**RIVERBEND RESIDENTIAL  
DEVELOPMENT**  
**PRELIMINARY GRADING PLAN**

DESIGNED BY:	DLM	DRAWN BY:	DBM
SCALE:	1" = 100'	DATE:	01/29/20
JOB NUMBER	17-114	SHEET	3 OF 3

COUNTY FILE NUMBER: PCD File No. SP187

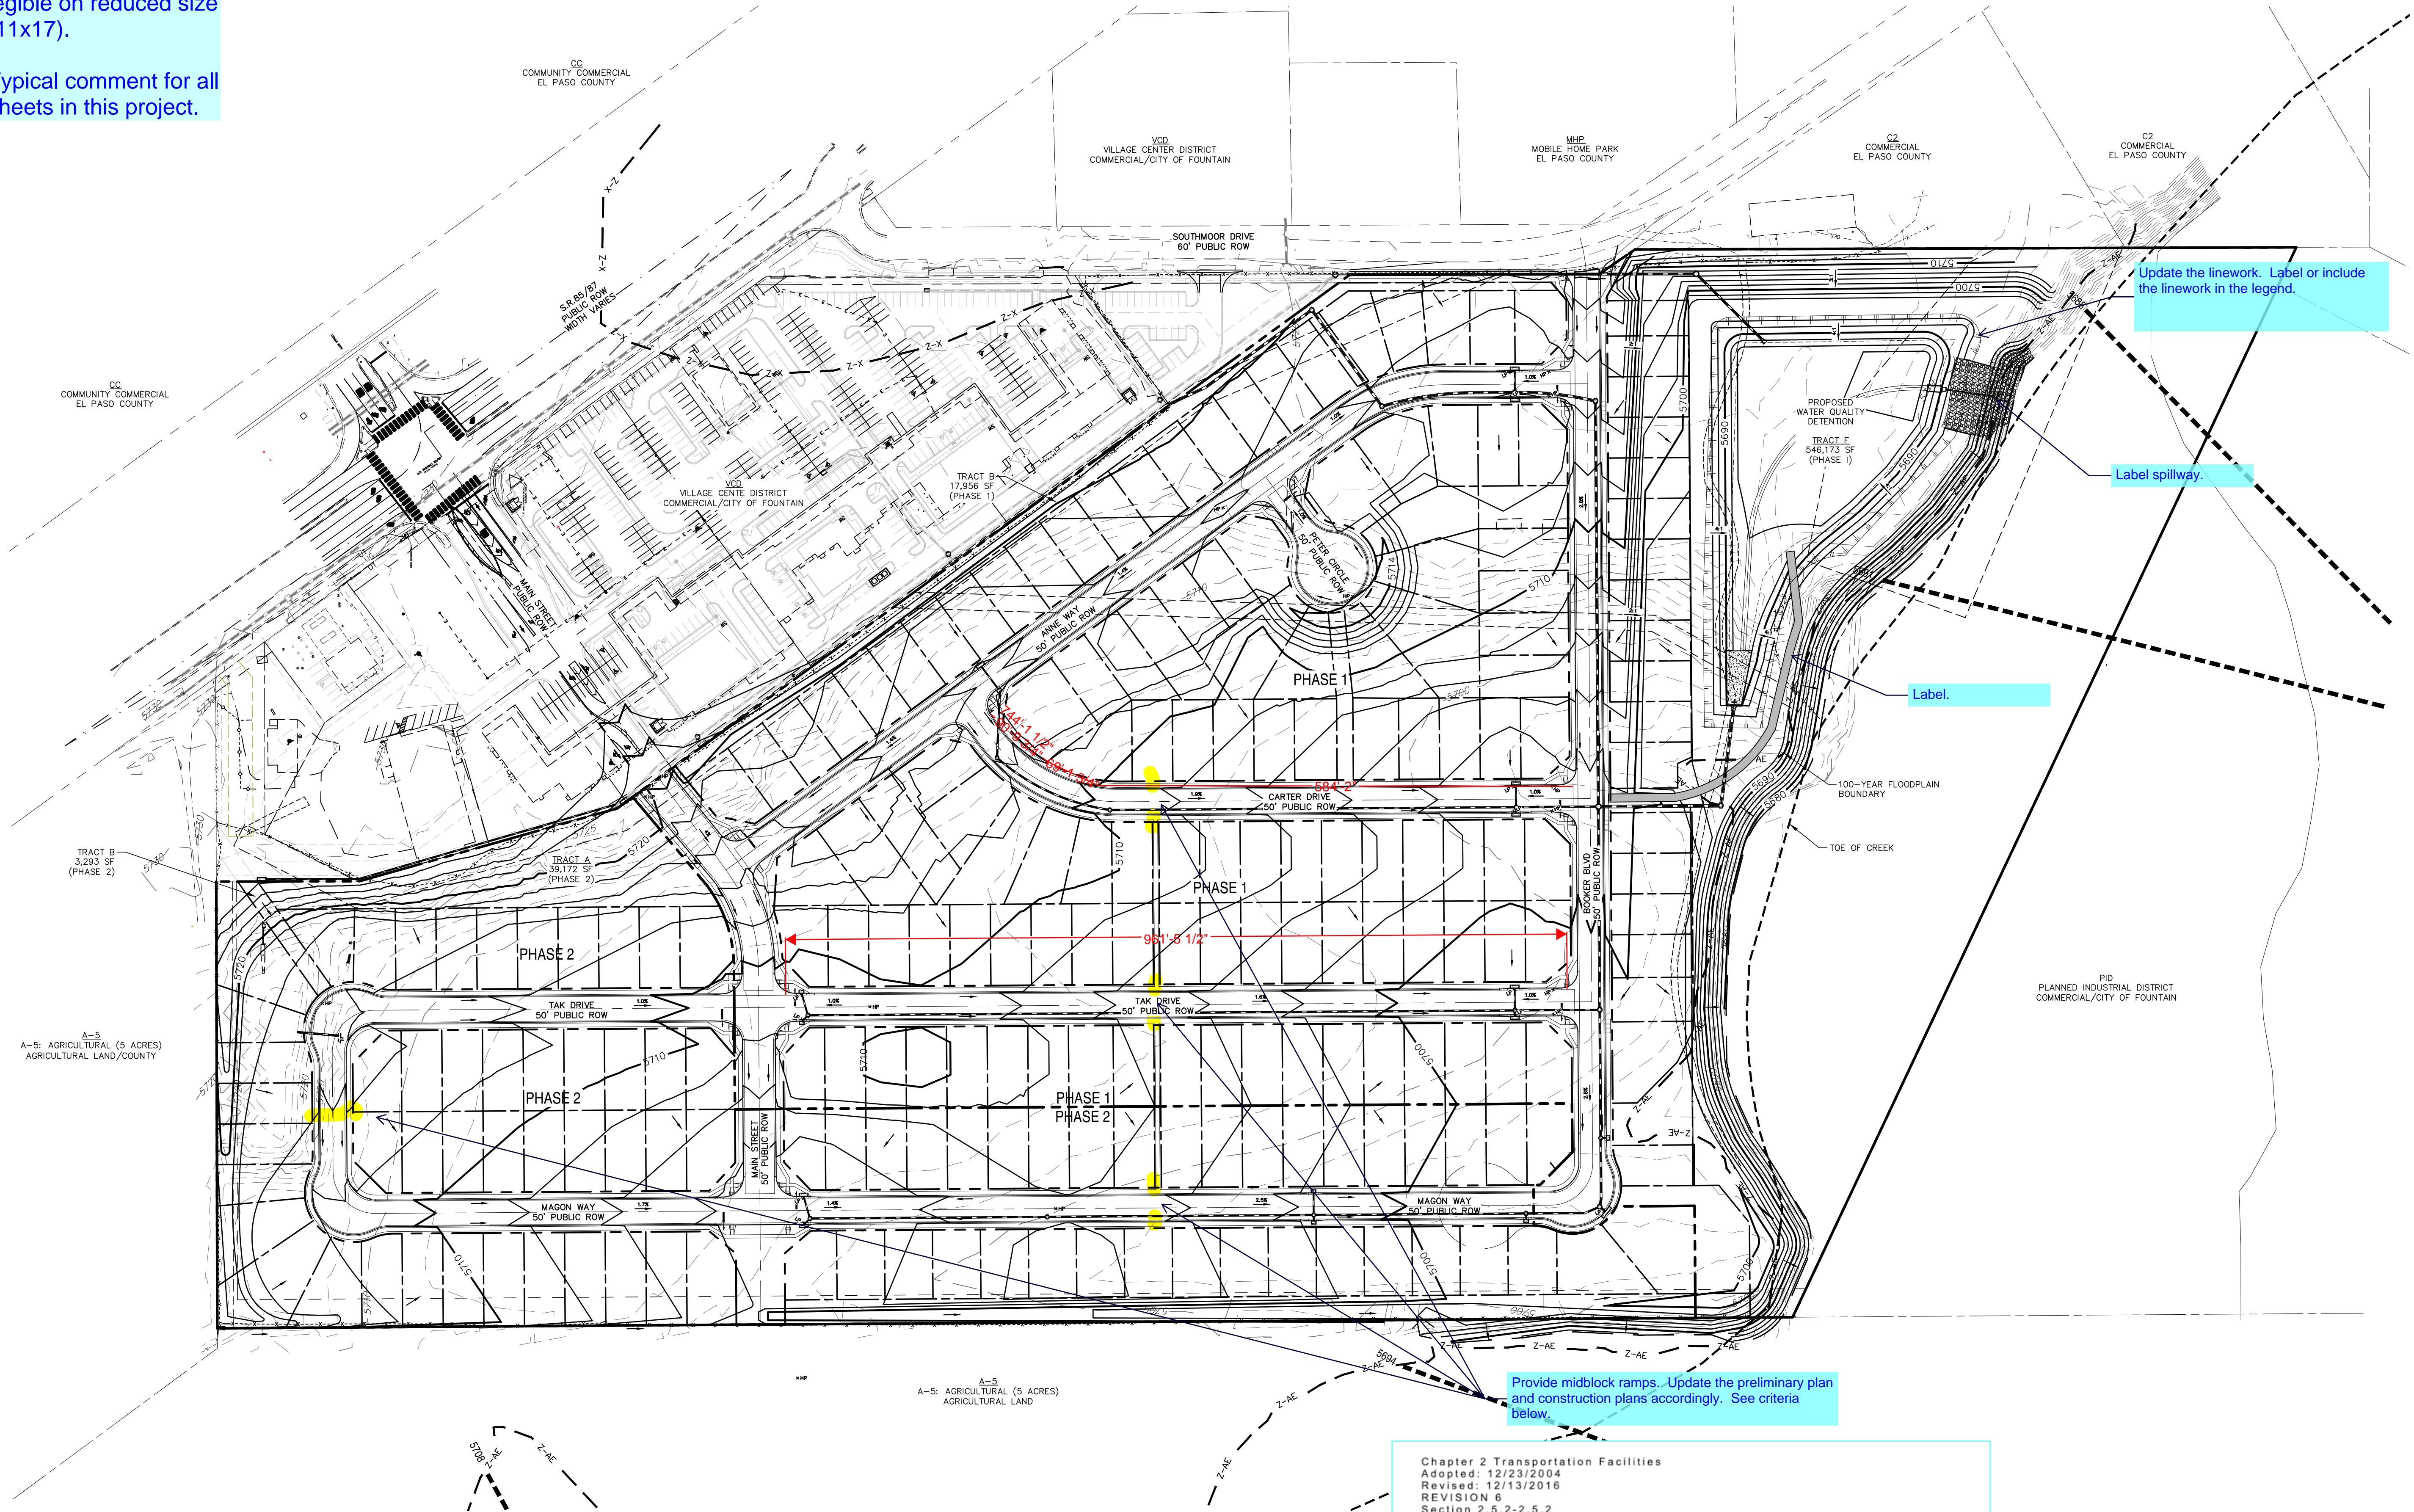
Increase text size to be legible on reduced size (11x17).

Typical comment for all sheets in this project.

Provide midblock ramps. Update the preliminary plan and construction plans accordingly. See criteria below.

**4. Mid-Block Ramps on Local Roadways**  
Access ramps on local roadways shall be spaced no greater than 600 feet apart. Where spacing is greater than 600 feet, mid-block access ramps shall be provided at spacings that minimize travel distances between access ramps. Private accesses may be used for these access points where the access is designed to meet access ramp requirements. The pavement markings and signing required by the ECM and MUTCD shall be provided for mid-block access ramps.
